M/9/19/HH

PLAN-026850

Proposal: Two storey rear extension, porch to front and conversion of roof space with two front dormers.

Site: Fidra Yapton Road, Middleton-On-Sea, PO22 6DX.

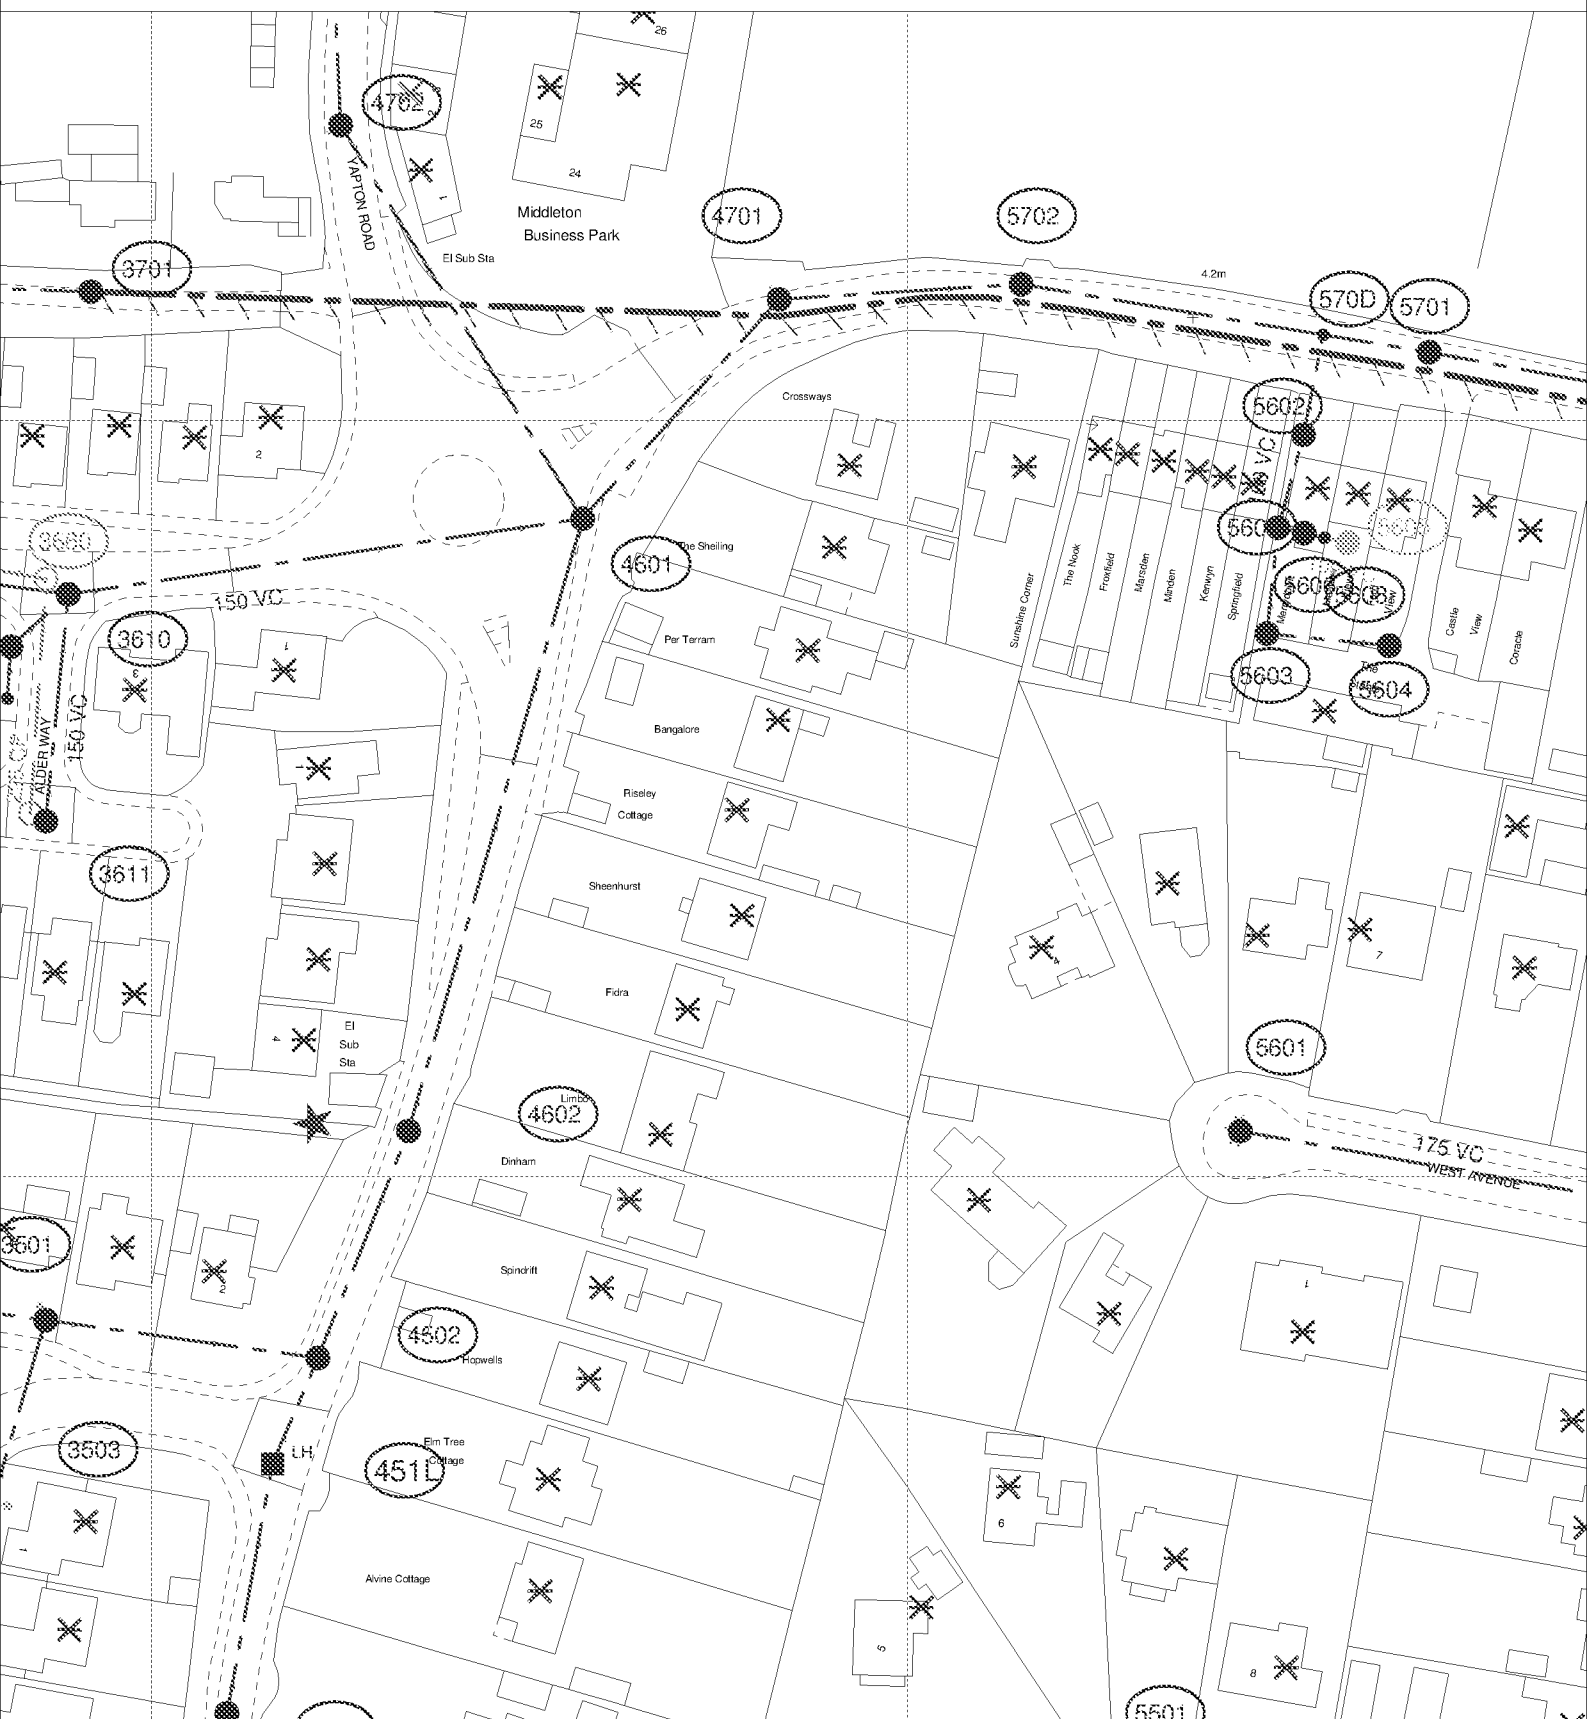
Due to surface water inundation issues in the Lidsey Catchment "The applicant is advised to adopt, where appropriate, the measures in the table "Practical measures to reduce the potential impacts of development".

Developer should look to protect the public sewerage system from inundation and infiltration, which contribute to flooding in unfavourable conditions.
